Re: Staff Review and Recommendation for the Resubmittal of the Preliminary Plat of Field's

Edge Addition

APPROVING THE PRELIMINARY PLAT OF FIELDS EDGE ADDITION

Site Photo 1/3: Silt Fencing Along South Property

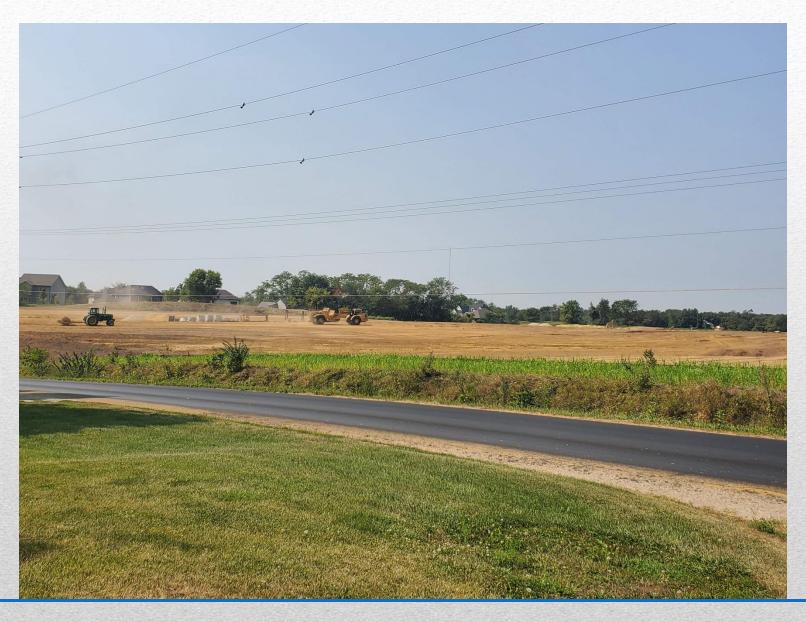
Staff has visited the development site recently and observed silt fencing installed at the site. Also of note, significant grading is currently occurring on 40-plus acres of property proposed for a single-family residential development in the City of Bettendorf. This property is located directly west of the Field's Edge Development, across Criswell Street, and drains into the same unnamed water source as the Field's Edge Addition development.
